SAN ISIDRO GOLF CLUB
SAN ISIDRO (1634) - BUENOS-AIRES - ARGENTINA

SITE REPORT FOLLOWING VISIT IN OCTOBER 07

A D A M G O L F D E S I G N
ARQUITECTOS DE CANCHAS DE GOLF

HOLE N° 9

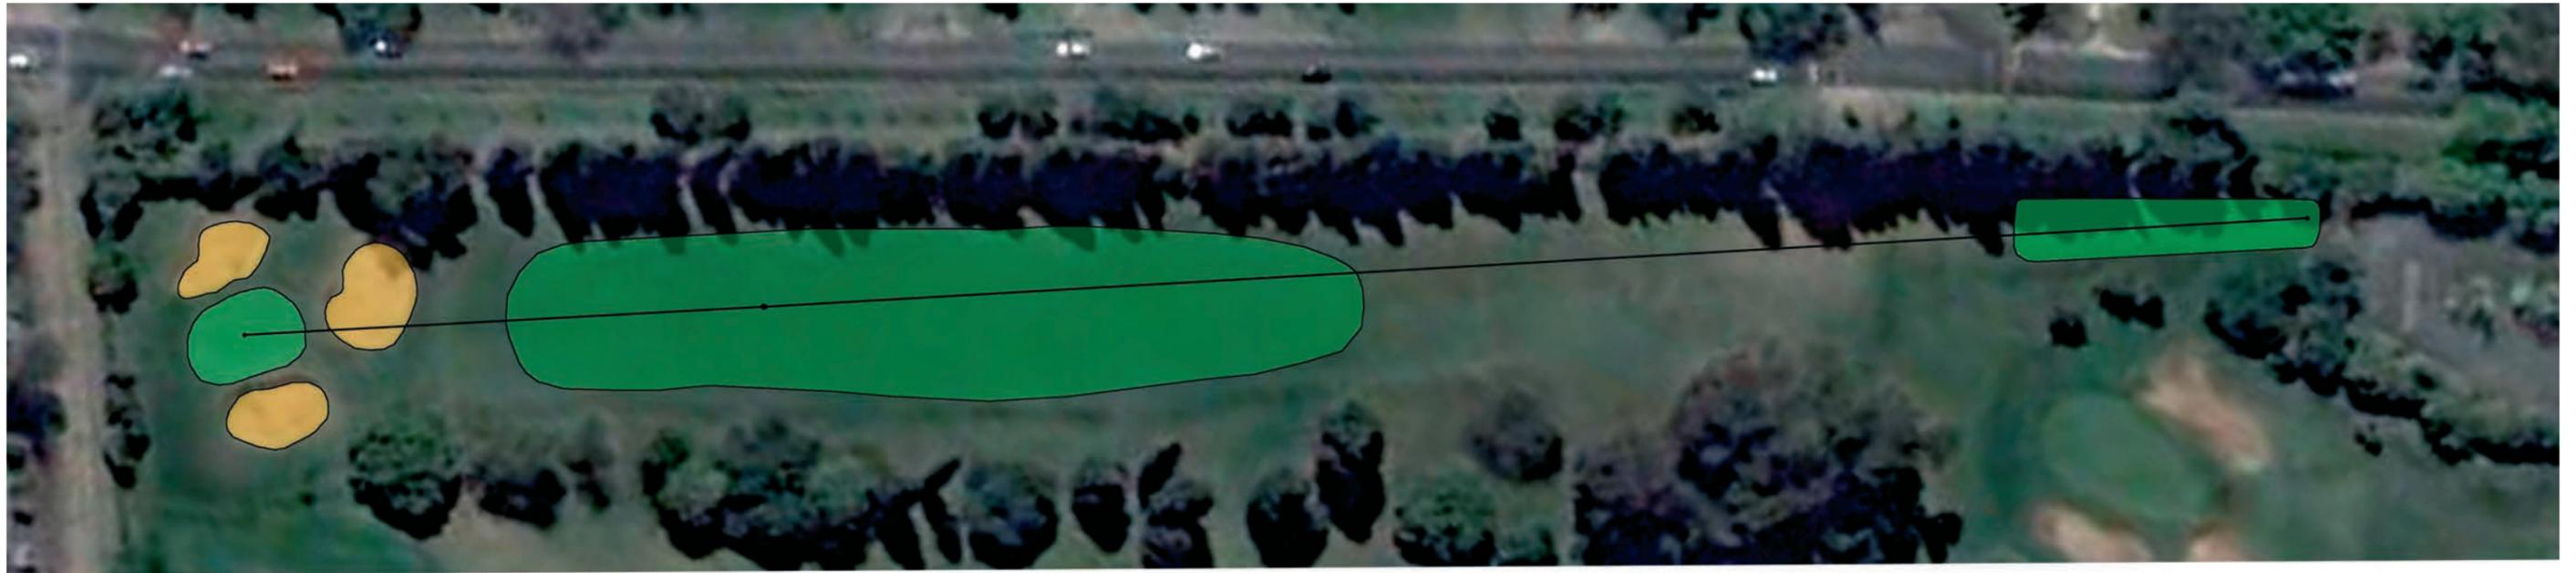
On this hole the concern was the positioning of the existing bunker in the middle of the fairway, that was penalizing the high handicap player. We propose to modify the hole by making it much more strategic in its design. Rather than just having to carry a cross bunker as at present, we wish to privilege risk/reward and positioning. The ideal line of play is as indicated with the proposed center line which permits a much easier second shot to the green totally open from that angle. To play that line the golfer will need to flirt with the left hand side bunker and optically he will be led to think that he must carry the right hand side bunker. The ideal drive will reward the player with an easy second shot. If on the other hand the player wishes to be cautious, he will need to be just short of the left hand side bunker. This will leave him with a more difficult second shot, as the green will be protected by an existing bunker that we propose to enlarge so as to discourage the run up shot. The proposed strategy will also be enhanced according to the various pin positions.

HOLE N° 11
EXISTING

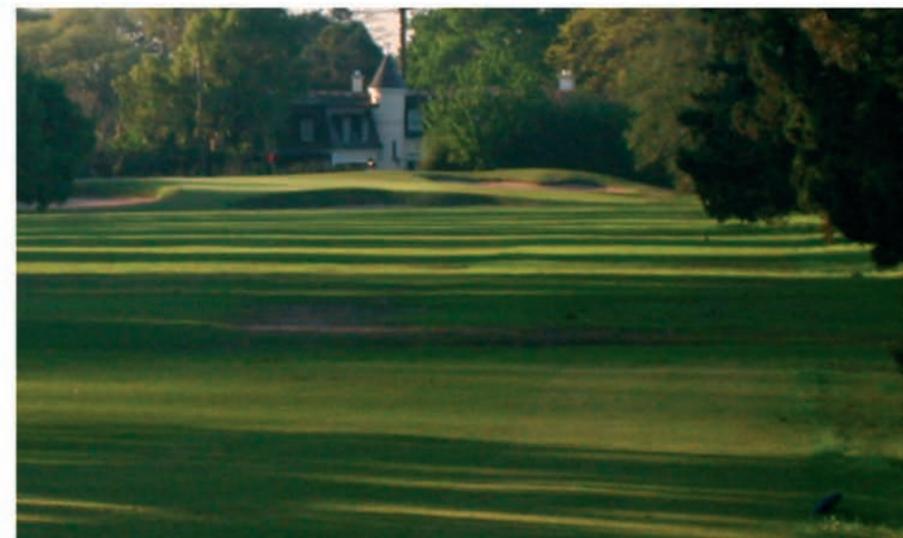
On this hole the major concern was the number of balls going onto the road. In order to help remedy this situation, we propose to shift the center line towards the left hand side and to enlarge the fairway on the left hand side. To reinforce this line of play we propose the positioning of a fairway bunker on the right hand edge of the fairway. This will be a visual maker for the players and will help them line themselves up. With regards to the existing tee box, we propose to re-align it with the proposed center line. As with hole number 4, we propose that some dense planting be put in place alongside both the existing men's and ladies tees. The positioning of this vegetation as the ball rises from the tee rather than at the end of its flight has been shown to be more effective both physically and psychologically.
